Docket Item #6  
BAR CASE# 2005-00053

BAR Meeting  
March 23, 2005

**ISSUE:** Alterations  
**APPLICANT:** Darrell Jones  
**LOCATION:** 1018 Queen Street  
**ZONE:** CL/Commercial

**Figure 1** Existing north elevation

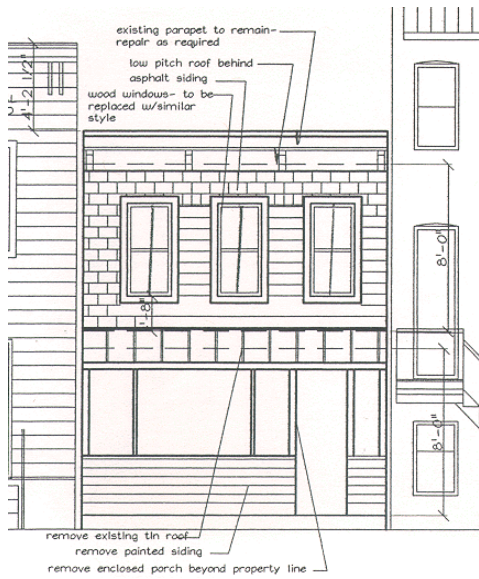
Front (north) facade - The front is to be clad in painted 8" wide beveled wood siding, according to information provided by the applicant. This does not match the existing siding which Staff has examined and believes to be original. The existing wood siding on the front of the house is an unusual variant of German siding. It has a bead in the scoop above the flat surface of the board and a reveal of approximately 5". Portions of the existing siding on the front are damaged or missing. Further exposure of the siding would be necessary to fully evaluate whether it can be retained. The siding on the sides and rear is likely to be a simpler type siding. That visible on the west side appears to be a plain lap siding.

The existing wood two-over-two windows will be replaced with new wood two-over-two windows with true divided lights manufactured by Kolbe and Kolbe. The new windows will be sized to fit the existing window openings. The drawings are incorrect in that they show different trim on the first and second stories. The applicant has confirmed that the existing trim, which is the same on both stories, will be retained. The existing half light front door will be replaced with a new wood four panel door (Model #704 by JELD-WEN). The drawings are incorrect in that they do not show the extant transom. The transom must remain. A single brick step will be added at the front door. A brass lantern style light fixture (Model Y38039-PVD by Hampton Bay) will be installed beside the door. The existing Italianate wood cornice will be retained. The new roof will not be visible beyond the cornice. The siding will be painted “Bay Leaf” by Behr and the trim will be beige.

1. That the existing transom at the front door be retained;
2. That the existing window trim at the front be retained with the top and bottom trim matching;

3. That the existing front siding be retained, if at all possible, or be replaced with German lap siding with a 5" reveal to match the existing as closely as possible, with Staff to approve the use and type of replacement siding prior to ordering or installing.

**Figure 4** Proposed east elevation

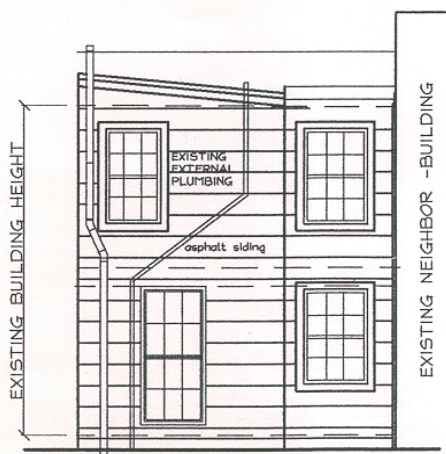
East side facade - The east side facade will be raised approximately 2.5' in height. The existing bricktex siding will be removed and it will be clad in new 8" beveled wood siding. The siding will be painted "Bay Leaf" by Behr and the trim will be beige. The fenestration on this facade will be rearranged. The existing first story has from left to right, a door and two six-over-six windows in a non-symmetrical arrangement. The existing second story has three six-over-six windows located toward the right side of the facade. The new east side elevation will be composed of, from left to right, a paired windows and a pair of multi-light doors on the first story and a paired window and a single window on the second story. Unlike the existing openings, the new openings will be aligned vertically. Although the drawings show six-over-six windows, the windows will be two-over-two wood windows with true divided lights, according to the applicant.

This facade is not visible from Queen Street and is visible only in minimal glimpses from the public alley at the rear.

**Figure 6** Proposed south elevation

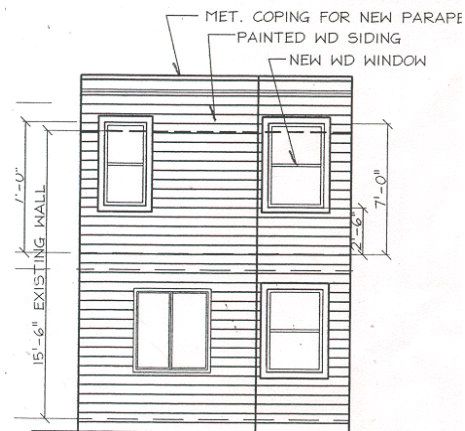
The rear wall will be raised 2.5' at the top. The bricktex siding will be removed and new beveled wood siding will be installed. The siding will be painted "Bay Leaf" by Behr and the trim will be beige.

The window on the first story will be changed from the existing rectangular double hung sash to a wider and shorter window. Although the drawings appear to show this window as a casement and the second story window as one-over-one window, the applicant states that these new windows will also be two-over-two wood windows with true divided lights.
